Xavier Rixhon's PhD thesis - Answers to jury members

Exploration of uncertainty-aware energy transition pathways -
Reinforcement learning and principal component analysis-based
methods

Figure 1: Storage installed capacities for the REF case

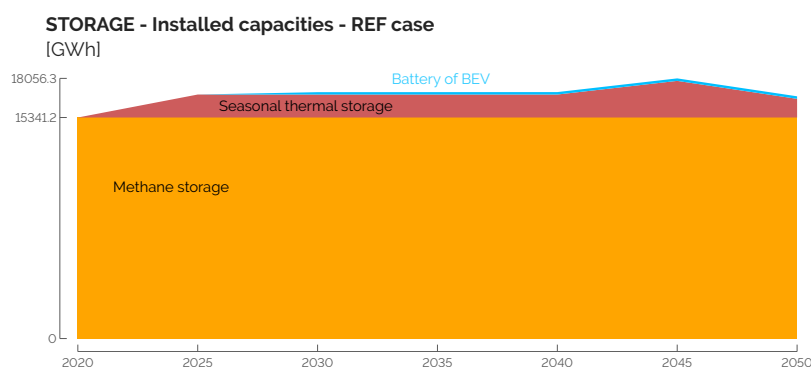
Stefan - Some big topics are missing like storage. Why is storage not more discussed?

As discussed during the private defense, storage is not more discussed in the manuscript for two reasons. First, the storage technologies, for the case of Belgium assuming a copper-plate approach, consist in two main technologies: methane storage mostly (about 15 TWh) and, to a smaller extent, seasonal thermal storage (about 3 TWh), with limited variations through the transition (see Figure 1). Analyses under uncertainties have not shown major variations neither. Second, storage assets are intrinsically linked to the conversion technologies and, consequently, can be seen as by-products of the optimisation results. For these two reasons, I have rather focused my analyses on the use of resources and the installation and operation of conversion technologies. Given the discussion during the private defense and these further explanations, I have not brought modification to the manuscript in this regard.

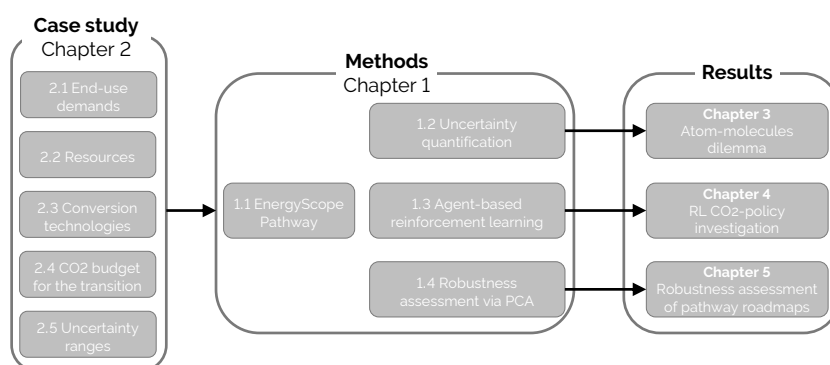
Stefano & Stefan - The thesis structure makes it quite difficult to follow. Having all the methodology summarised in Chapter 1, makes it difficult to link it to the different chapters. As changing the structure may be now a major work, I would invite you to think how to better connect the different parts.

Finally, I have added a schematic at the end of the Introduction of the thesis to clarify the structure and highlight that Chapter 4 and 5 can be read after the methodological sections 1.3 and 1.4, respectively (see Figure 2).

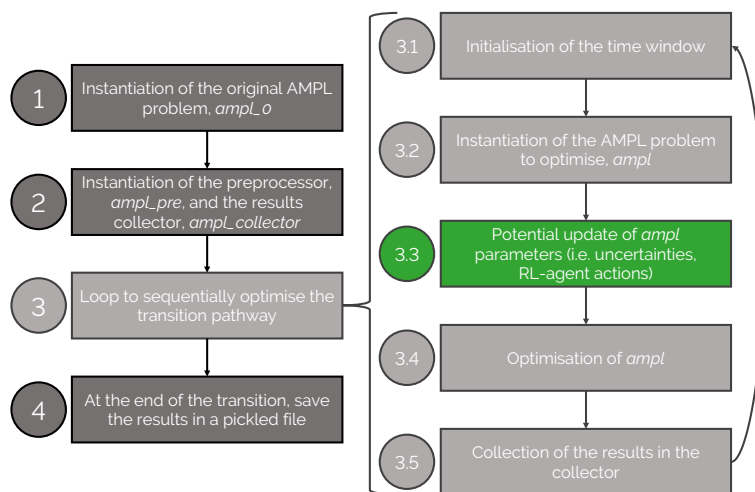
Stefano - p.17-19: is the myopic version modeled as a single LP or as a sequence of LPs? This should be better clarified. The diagram at p. 19 focuses on the code, it would be better replaced by a code showcasing the logic of the approach.

and extended the caption of Figure 1.4. However, besides highlighting the key step 3.3 where there is an update of parameters value, I have decided to keep the figure as is since, on the one hand, the extension of the caption provides now a better understanding and, on the other hand, the code itself is exactly what is schematically represented on the diagram.

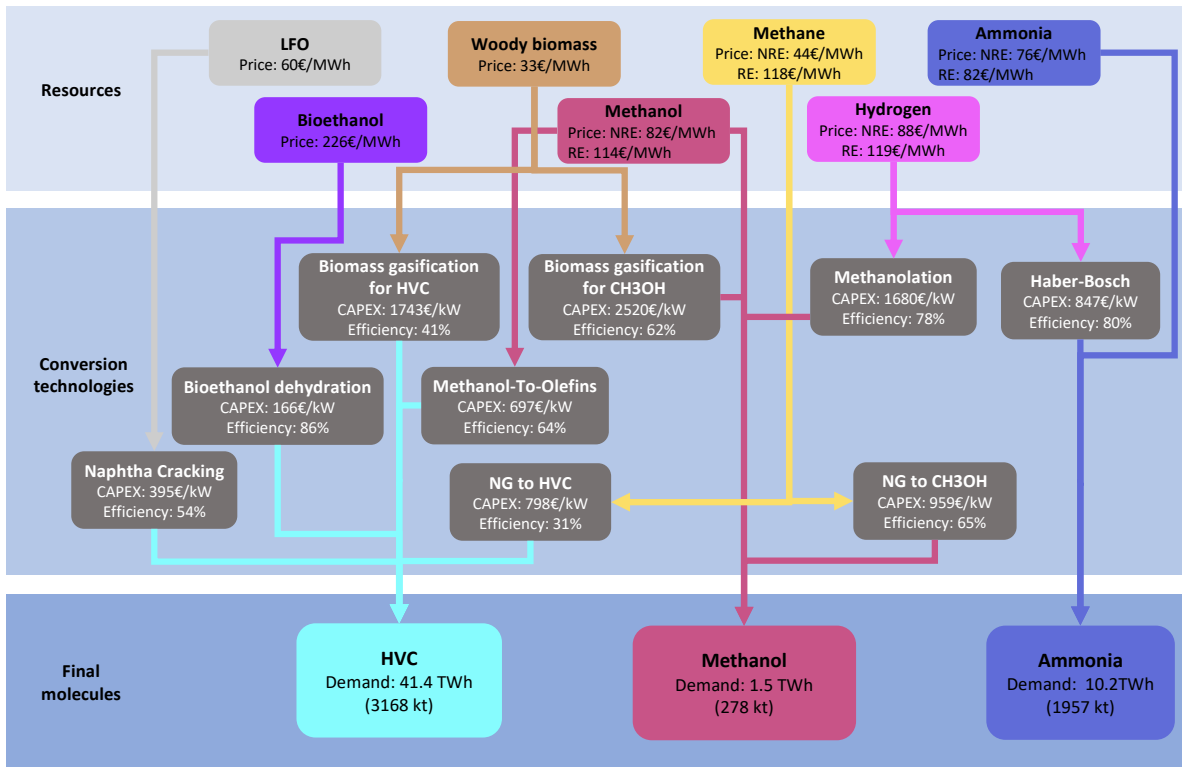
Stefano - Figure 2.5: What is the purpose of the violet line between “biomass gasification” and “methanolation”?

These were actually two different arrows, one pointing from “biomass gasification for CH₃OH” to “Methanol” and the other from “Methanolation” to “Methanol”. To avoid this confusion, the figure has been updated and the origin of these arrows are now on different vertical levels ([see Section 2.3](#)).

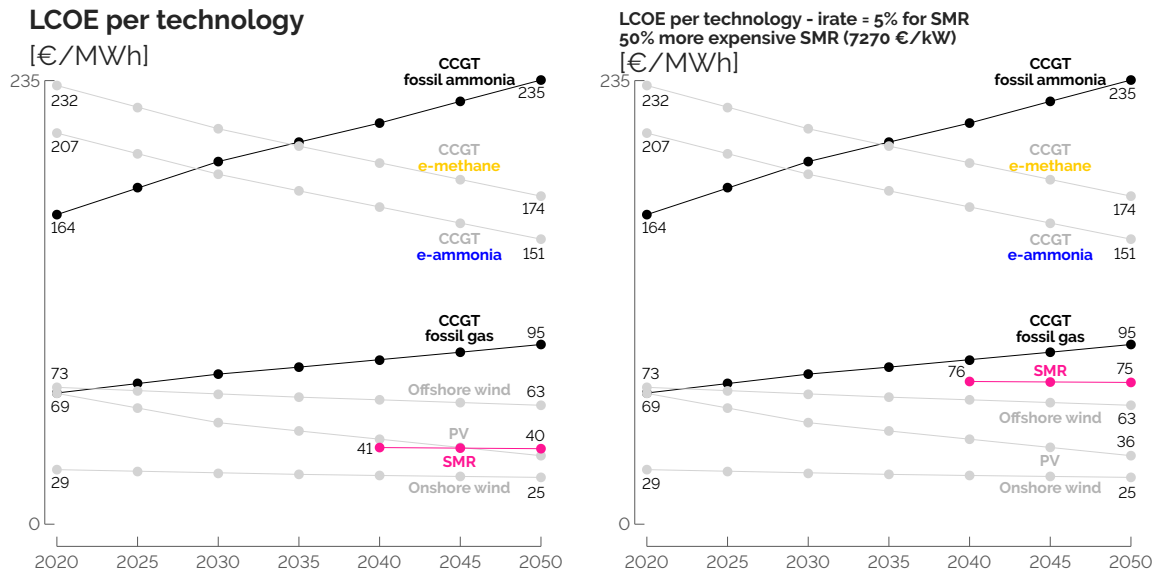
Sylvain - p. 53 What about fuel cost?

On top of the uncertainty applied to the CAPEX of SMR [-40%, 44%] considered in the thesis, I carried out a test on these assumptions by plotting the LCOE of electricity-production units considering different assumptions for SMR (see Figure 4.4). Even considering 50% more expensive SMR subject to a higher discount rate (5% versus 1.5% for the other technologies), we notice that SMR keeps on being more cost-competitive than other flexible production units, like e-ammonia CCGTs, that are substituted by SMR when the latter can be installed (see Chapter 3). In other words, it means that the optimistic values assumed for SMR in the thesis lead to a cheaper whole-energy system but does not affect its design, i.e., the installed technologies. Consequently, no further modification has been brought to the thesis regarding this comment.

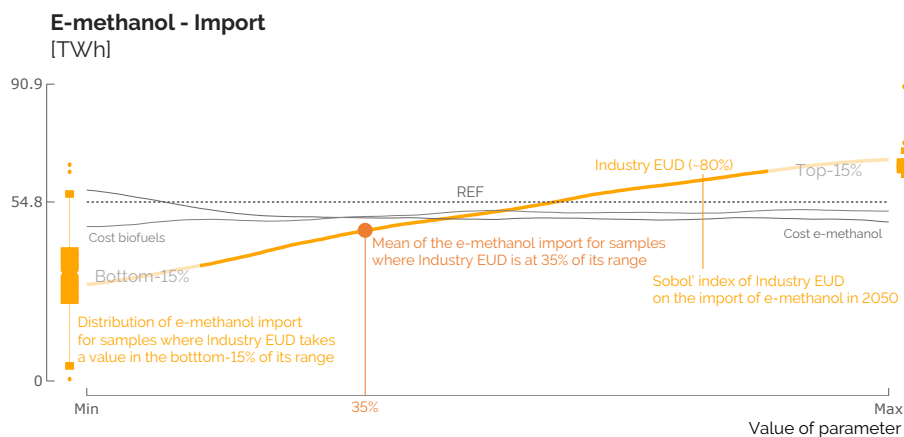
Stefano - p. 74, Figure 3.8: this graphs looks potentially interesting but it is not sufficiently well explained.

The objective of this set of figures is to point out the key parameters that drive the variation of some outputs of interest. Taking the case of Figure 3.8, we focus on the import of e-methanol in 2050. On the x-axis, we represent the value taken by the uncertain parameters in the different samples. As the range is not the same for all the parameters, we have limited this axis from “Min” to “Max”. The y-axis represents the feature of interest. The drawn lines represent average trend lines between the output of interest and one specific parameter. For the case of Industry EUD, for samples of the GSA where this uncertain parameter is at 35% of its range, the mean value of methanol imported in 2050 is roughly 50 TWh. The distributions present on the extreme left and right of the graphs correspond to the distributions of the output of interest for the samples of the GSA where the considered parameter takes a value in the bottom (left) or top (right) 15% of its range.

To improve the readability of this figure, I have updated the text zones to specify that these lines and distributions represent results of some specific samples of the GSA. Additionally, I have added a text zone to remind that the value between brackets is the Sobol’ index of the considered parameter regarding this specific output of interest, and added this information in the caption of the figure:
